ADDENDUM

Addendum No.: **THREE (003)**
Project: KCKCC Field House Addition

Project No.: 22060A
Date: October 25, 2023

DOOR TYPES
1/4" = 1'-0"

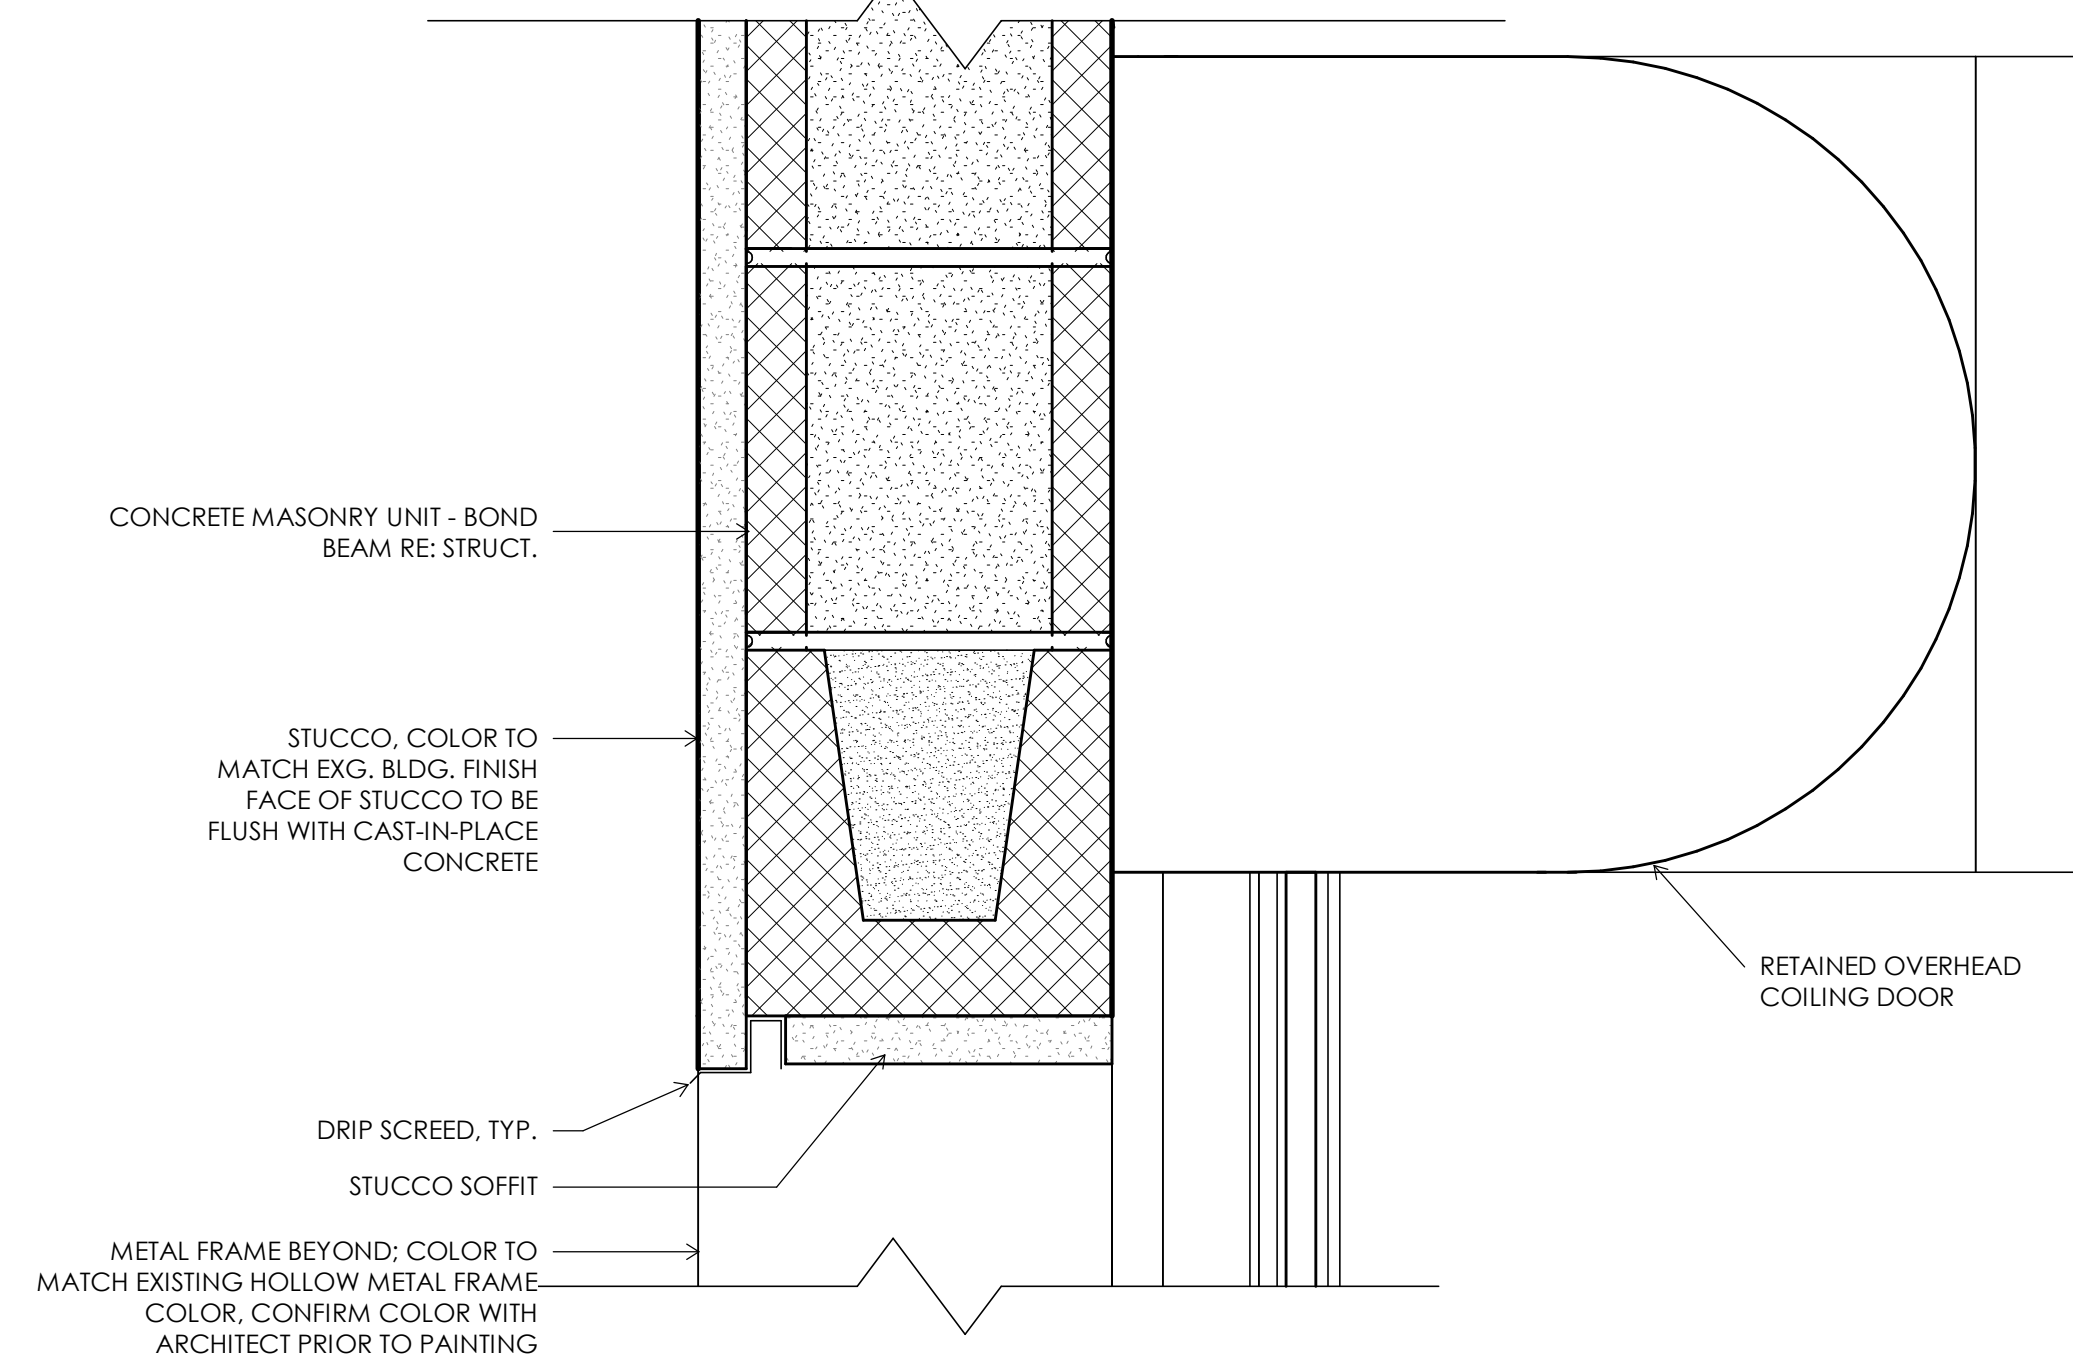
A. Sheet A6.01 – Door Schedule

- i. See added Door Type 'D3', added Door Schedule Key Note 4, and revisions made to the Door Schedule.

- i. Answer: E9/SP1.01 should be updated to read, "G10/SP1.01."
- F. Question: Please provide an elevation for the door types D3 and D4.
- i. Answer: Aluminum Door 102A should be Door Type 'D1.' Hollow Metal Door 102C should be Door Type 'D3.' The Door Schedule and Door Types will be updated to show this correctly. See attached A6.01.
